**Flood Control Project Maintenance
Levee Inspections**
LMA District Cover Sheet
Spring 2017 Levee Inspection Results

California Department of Fish and Game Shea Levee

Levee Inspection Report By Mile - Spring 2017

Waterway	Bank	Unit Miles	Inspection Start/End	Inspector
Unit No. 01 Sacramento River	Left	0.30	04/17/2017 04/17/2017	Bob Duffey

Photo 1 of 2 : SP_2017_NA0018_269_4_20170315_00005.jpg

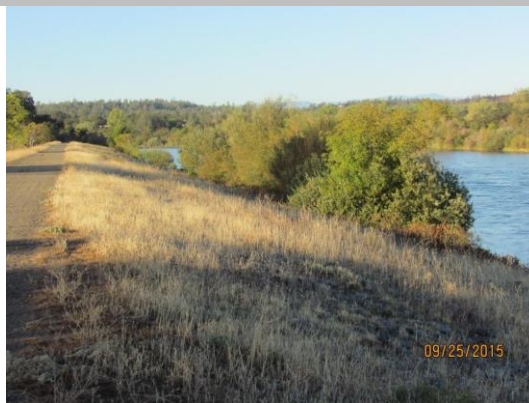
LM Start	0.21	Rating **	M	Issue No.	4
LM End	0.26	Issue Type +	Ma	Location *	LS
Category	Earthen Levee			GPS Latitude/Longitude	
				Start	End
Item	Trim / Thin Trees			40.511518 °	40.508234 °
				-122.360100 °	-122.363430 °
DWR ID	DWR_NA0018_01_s _ 2012_4				
Comment Code					
T3 : Trim and thin trees to allow visibility of the ground and room to flood fight.					
Inspector Comment					
Trim the trees on the landside and waterside slope

Trim the trees along the waterside slope.
